# Service Bulletin

Bulletin No. GT-34

Subject: GT500 SHIFTING CAM GUIDE BOLT LOCATION  
REFERENCE: Service Bulletin #T-5

Subject: GT250 CYLINDER HEAD, SPARK PLUG  
AND CARBURETION CHANGES

Bottom View of Lower Crankcase Hal

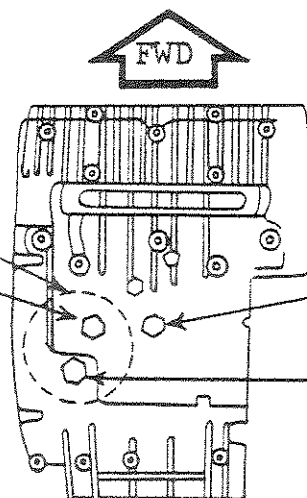
We have received occasional reports of GT500 transmission failure immediately after an engine or transmission overhaul. Upon disassembling and inspecting the transmission, it was found that the transmission oil drain plug and the shift cam guide bolt had been mistakenly interchanged during the overhaul.

The shift cam guide bolt restricts the shift cam drum from sliding from side to side inside the crankcase assembly. When these two bolts are interchanged, the oil drain plug does not extend into the locating groove of the shift cam drum, allowing the drum to slide from side to side. When this happens the shifting forks slide with the shift cam, allowing two sets of gears to become engaged at the same time. This results in severe damage to the gears, and requires their replacement.

NOTE: Remove both bolts to drain oil. After draining oil make sure of correct placement of both bolts.

Therefore, whenever a GT500 is overhauled, or the transmission oil changed by your service department the final inspection after re-assembly should be the proper placement of the shift cam guide bolt and oil drain plug.

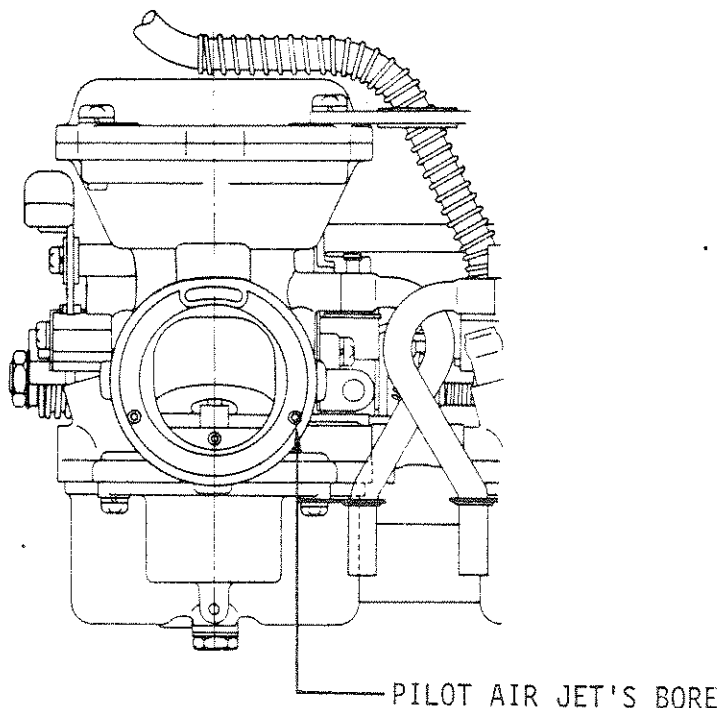
Certain GT750's equipped with Constant Velocity (C.V.) carburetors may experience a "surging" or "bucking" problem on deceleration or part throttle cruising conditions.

Extensive carburetion testing has shown that by reducing the pilot air jet size, these characteristics can be minimized or eliminated.

GT750 pilot air jets are pressed into position and cannot be removed. Therefore, an additional reduction air jet must be installed in the pilot air circuit. Reduction air jets are now available and come in the two sizes listed below:

REDUCTION PILOT AIR JET	
#80	0.80 mm DIA.
#90	0.90 mm DIA.

The #80 reduction jet would normally be used in the 1975M, 1976A, and 1977B models. The #90 reduction jet would normally be used in the 1974L model. These are the suggested applications and depending on geographical area and engine conditions, it may be necessary to select the alternate jet.

### INSTALLATION:

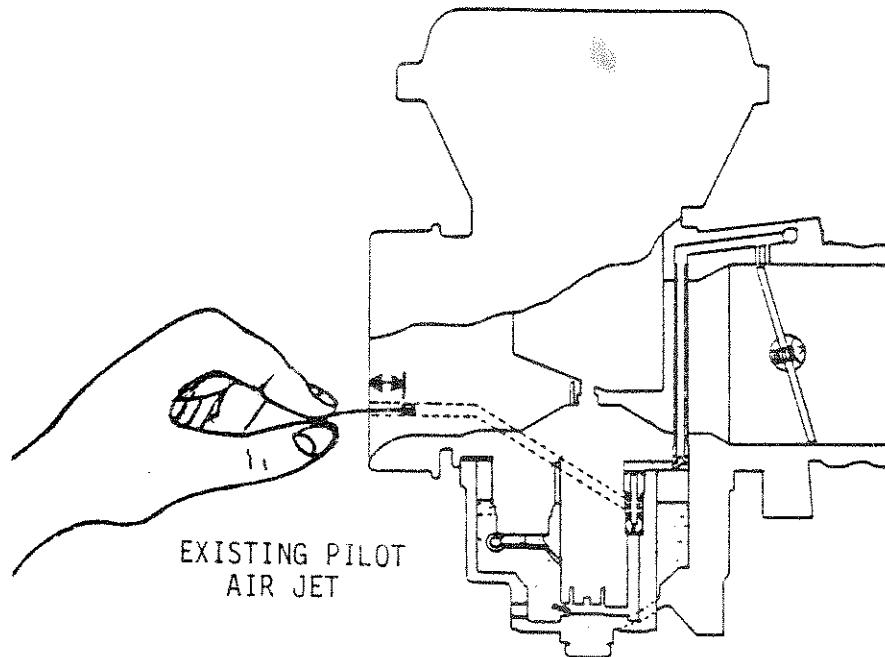
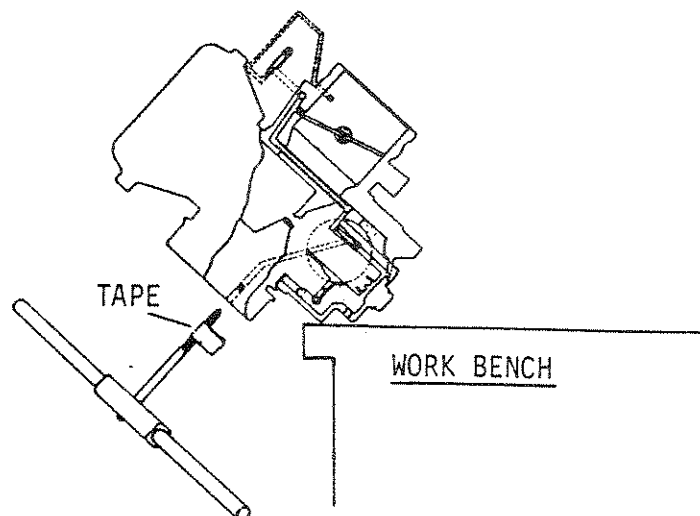
1. Remove the carburetor assembly.
2. Place the carburetor assembly on a clean work surface.
3. Using a fine piece of wire, measure the distance that the existing pilot air jet has been inserted into the pilot air intake tract, as illustrated below:

4. Place a piece of tape (to be used as a reference point) on a 4 x 0.7mm tap, 1mm less than the total distance measured with the piece of wire. This will prevent the tap from damaging the existing air jet.
5. Tilt the carburetor assembly so that the mouth of the venturi is tilted in a downward position. This step must be done to eliminate the possibility of aluminum shavings entering the existing pilot air jet.

6. Insert the tap until the tape reaches the flange of the pilot air intake opening. Remove the tap. Lightly knock the carburetor assembly against the work bench to remove all aluminum shavings.
7. Using Suzuki Thread Lock Cement, place one small drop on the threads of the new pilot air jet. Screw the new jet into the pilot air jets' bore until the head of the jet lightly seals against the flange of the bore.
8. Reinstall the carburetor assembly, adjust and synchronize the carburetors.
9. Test ride the machine to determine if the jet needle position must be changed as described earlier.

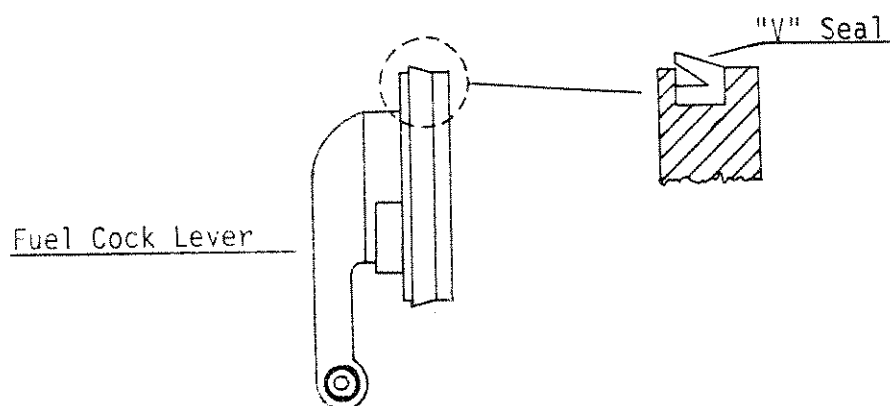
To prevent fuel cock seepage, a "V" seal has been installed around the fuel cock lever, to seal the lever to the fuel cock body, as illustrated below.

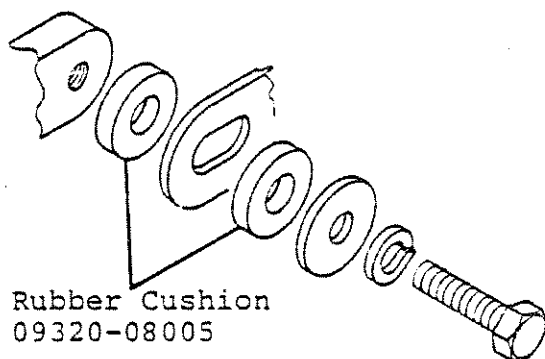
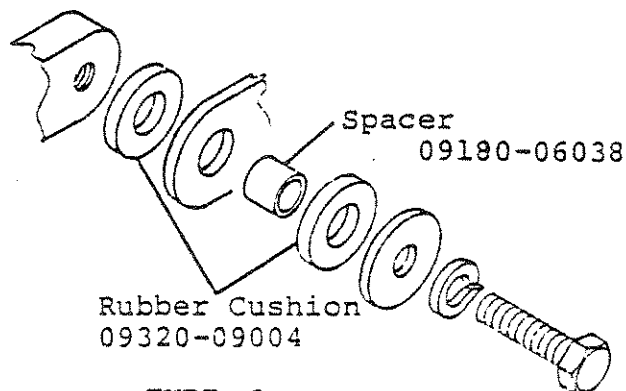
There are presently three ways to mount the A and B model GT500 front fender brace to the front fork outer tube. To distinguish the different mounting methods from each other, they are labeled the Original method, the Type 1 method, and the Type 2 method. If any original or Type 1 front fender has to be replaced, it must be updated to the Type 2 fender.

The Original method is a "rigid" mount with the fender brace bolted directly to the fork tube.

The Type 1 method is a "semi-floating" mount. A rubber cushion is used with the original type fender to provide a small amount of flexibility. With this type of mount, the mounting bolt must be secured with thread lock cement.

The Type 2 method is a "floating" mount. The front fender brace has been changed and it is mounted by a rubber cushion and a spacer. This mounting method will provide a secure yet flexible mount for the front fender.
